New Fire Station #10
St. Tammany Fire Protection
2745 Lakeshore Vista Blvd.
Slidell, LA.

Sheet Title: Landscape Planting Plan

JOB No.:
SCALE: AS SHOWN
DRAWN BY: AB3
CHECKED BY: AB3
SHEET:
LS-1
REV.
DATE: DECEMBER 18TH 2025

Flre Station 10 (revised mark up& summaryLA comments 1.27.2026).pdf Markup Summary

LANDSCAPE PLANTING PLAN

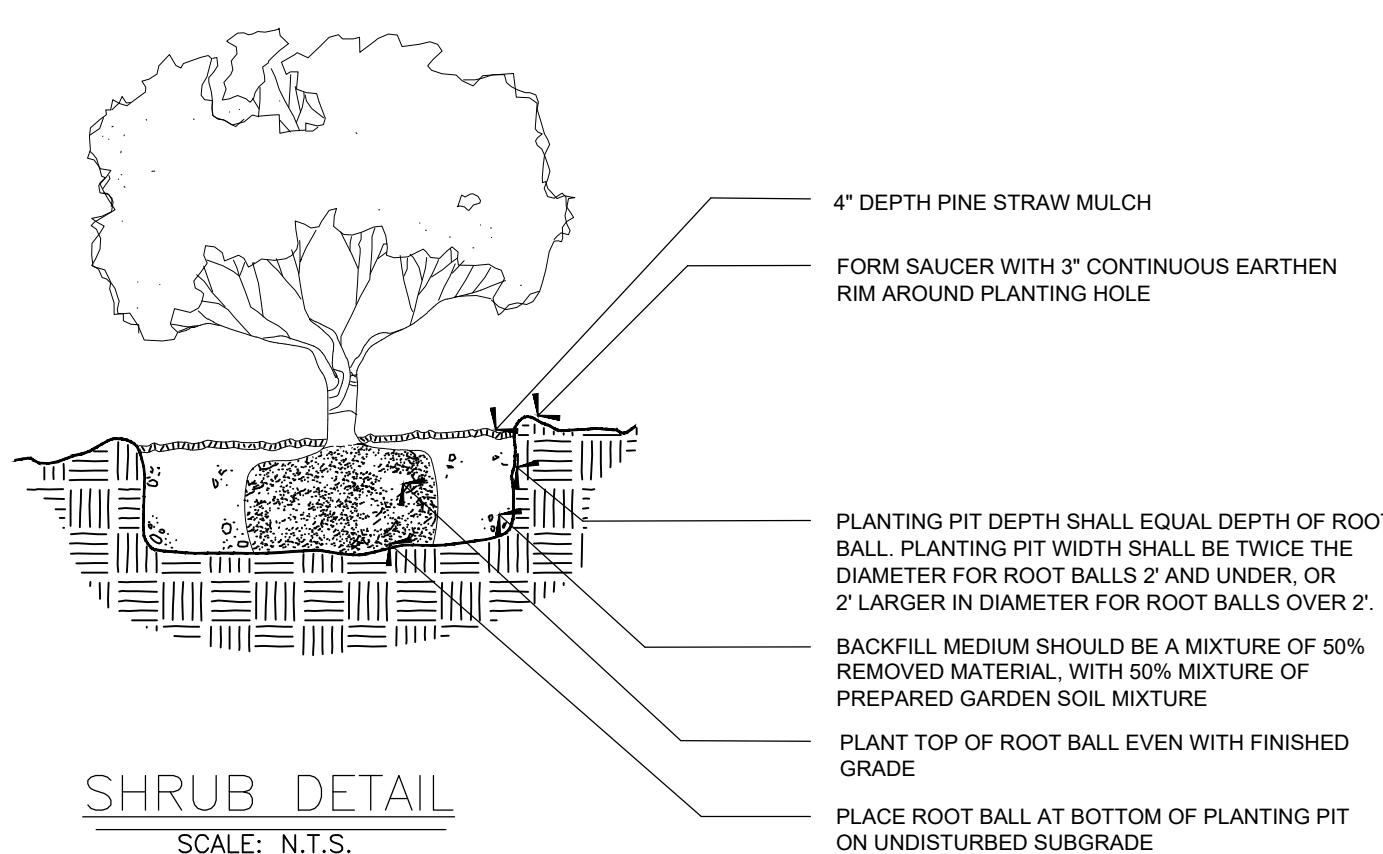
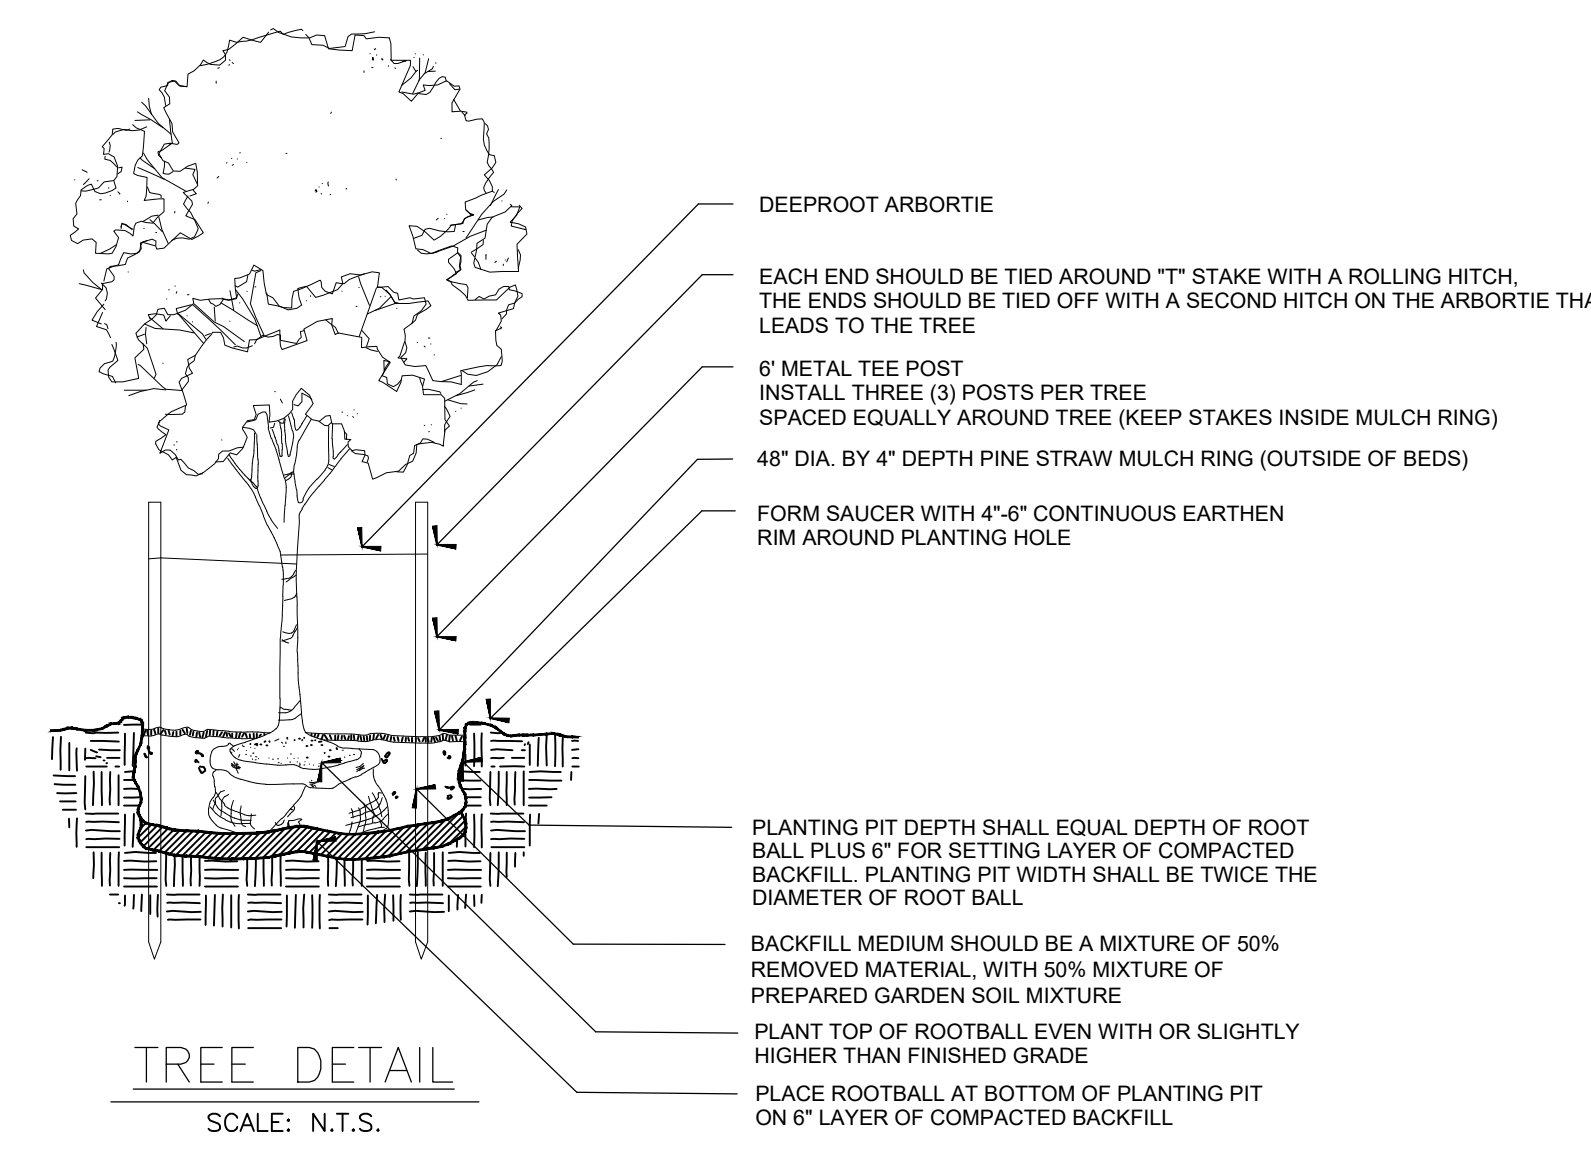
Provide 6" curb on all parking islands per UDC Exhibit 600-3-12 typical.

OK to eliminate island in this location per Ross Liner. Suggest bollard for safety.

Parking is not allowed in buffer unless per section 600-3-14 (f) Flexibility in street buffers. This does not meet the requirements. Revise plan or apply for BOA variance

Suggest moving these spaces to existing row on left side of bld as shown and connecting with sidewalk to entry.

Add note to plan: Variance for driveway width was approved via Board of Adjustment under case # 2025-4500-BOA

Civil plans show swales on 3 sides in the landscape buffer. Landscape buffer must be provided outside of any servitudes or drainage easements. Move buffer inward to provide required planting area as needed or relocate swales outside of buffers.

Indicate zoning of site on plan. LV-3 as Lakeshore Estates PUD.

Landscape Plan shall identify pervious/impervious areas to comply with Sec 600-3.4 (D)(1). Provide min. 30% pervious area.

Dimension all buffers, driveways, drive aisles, islands and typical parking spaces.

Parking islands must meet requirements of Unified Development Code Chapter 600-5.1 Parking Requirements. Provide 9x18' islands with Class 'A' tree and living ground cover and 6" curb at the end of each row of parking. Island required at the end of each row and max 12 spaces between islands.

Indicate the building square footage and use of all structures typical.

Per Sec 600-3-17, All storage areas containing 3 or more refuse, garbage, or rubbish containers or 1 or more dumpsters shall be screened on all sides with min. 7' high opaque fence constructed of wood or masonry. All properties which provide prepared foods, and all office and warehouse uses must provide a dumpster and meet the requisite screening requirements.

Coordinate utilities, civil and landscape package to avoid conflicts with existing and proposed trees per code. Typical. Specifically, review drainage and grading to ensure no cut or fill in buffers or below drip line of protected trees.

Add Note to plan that surrounding property is zoned LV-3 per teh Lakeshore Estates PUD. Proposed future use will be public or commercial use such as soccer fields.

Type C buffer (commercial to commercial) requires 3 Class B trees/100' AND 10 shrubs/100'. Please revised chart, plan and schedule accordingly.
